Access Compliance Report

Public Rights-of-Way

(Curb Ramps)

Intersection ID: 27841	Main Street: BALLANTYNE_COUNTRY_CLUB_DR	Cross Street: OLD_WAYSIDE_RD	Location: NW
ADA ID: 1D4AB868A55E	Ramp Type: Perp	Initial Pass/Fail: Fail	Overall Compliance: No
Severity Score: 26.25			
Codes/Mitigation Info/Possible Solution		Field Measurements/Component Compliance

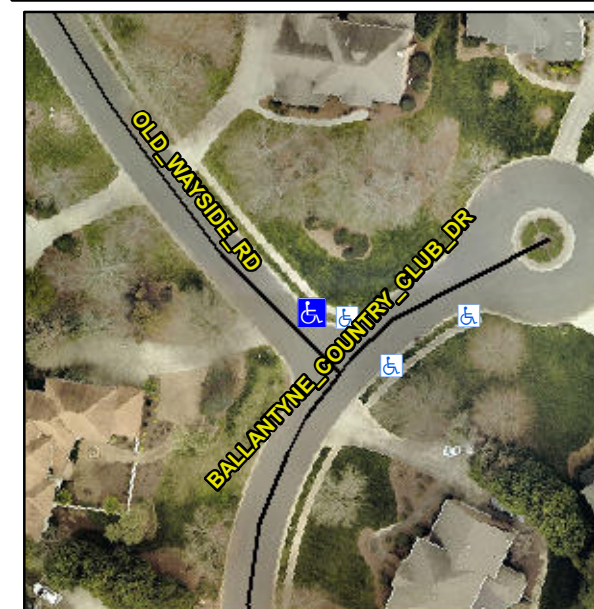
Not Found, R304.2.2, R304.5.3

Compliance	Description	Data	Compliance	Description	Data
N/A	Ramp Length (in)	48.0	No	Ramp Slope (%)	14.6
Yes	Ramp Width (in)	48.0	No	Ramp XSlope (%)	2.3
N/A	Flare Type LT	N/A	N/A	Flare Type RT	N/A
N/A	Flare Slope LT (%)	N/A	N/A	Flare Slope RT (%)	N/A
N/A	Flare Traversable LT?	N/A	N/A	Flare Traversable RT?	N/A
N/A	Landing Length (in)	N/A	N/A	DWS Provided?	N/A
N/A	Landing Width (in)	N/A	N/A	DWS Contrast?	N/A
N/A	Landing Slope (%)	N/A	N/A	DWS Length (in)	N/A
N/A	Landing X Slope (%)	N/A	N/A	DWS Full Width?	N/A
N/A	Landing Curb? (Y/N)	N/A	N/A	DWS Offset (in)	N/A
N/A	Shared Landing?	N/A			
N/A	Gutter Ponding?	N/A	N/A	Gutter Slope (%)	N/A
N/A	Gutter Lip Ht (in)	N/A	N/A	Gutter X Slope (%)	N/A
N/A	Painted X Walk1?	No	N/A	Painted X Walk2?	N/A
	X Walk 1 Direction	To SW		X Walk 2 Direction	N/A
N/A	X Walk 1 Width (in)	N/A	N/A	X Walk 2 Width (in)	N/A
	X Walk 1 Slope (%)	3.3		X Walk 2 Slope (%)	N/A
	X Walk 1 X Slope (%)	2.1		X Walk 2 X Slope (%)	N/A

N/A	Ramp inside XWalk1?	N/A	N/A	Ramp inside XWalk2?	N/A
	Road Slope (%)	N/A	N/A	Clear Space?	N/A
	Road X Slope (%)	N/A	N/A	Clear Space to XWalk (in)	N/A
N/A	Any Obstructions?	N/A	N/A	Storm Grate/Utility Hazard?	N/A
	Obstruction Type			Storm Grate/Utility Type	
		N/A			N/A
			Yes	Surface Condition? (G/P)	Good

Remove & Replace Entire Ramp.
